SERIAL NO.: 10/820,206 April 11, 2006 AMENDMENT A

Amendments to the Drawings:

REMARKS/ARGUMENTS

Serial No. 10/820,206 Amdt. 04/11/2006 Annotated Sheet 1 of 3 showing changes

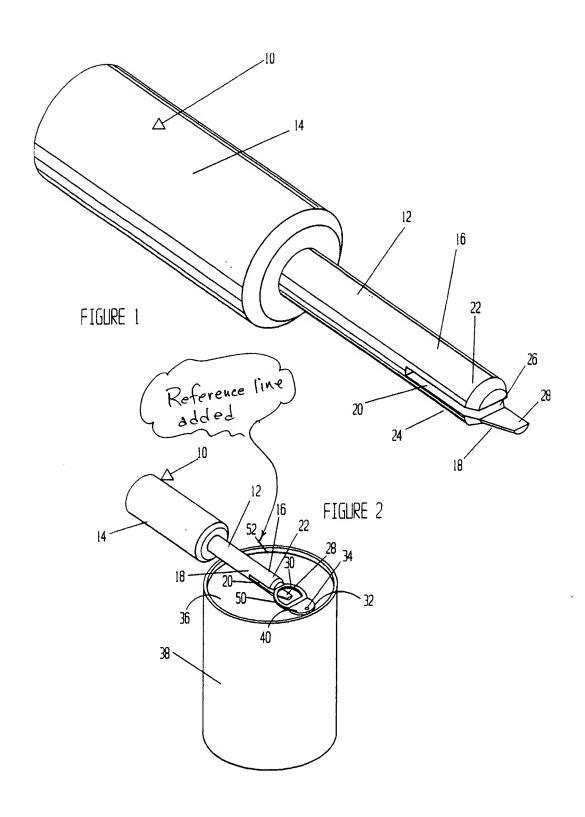
The attached sheets of drawings include changes to Fig. 2 and Fig. 7 to meet the objections raised by the examiner. It was also noticed that a similar correction was necessary to Fig. 4., The first of these sheets, which includes Figs. 1-2 replaces the original drawing sheet 1. In Fig. 2 a reference line has been added to numeral 52. The second of these sheets, which includes Fig. 4 replaces original drawing sheet 2 and Fig. 4 has been corrected to add a reference line to numeral 36. The third of the sheets replaces original sheet 3 of the drawings on which Fig. 7 now includes a a reference line to numeral 72.

Corrected drawings of Figures 2, 4 and 7 are submitted in the substitute drawing sheets 1, 2 and 3 which are attached hereto.
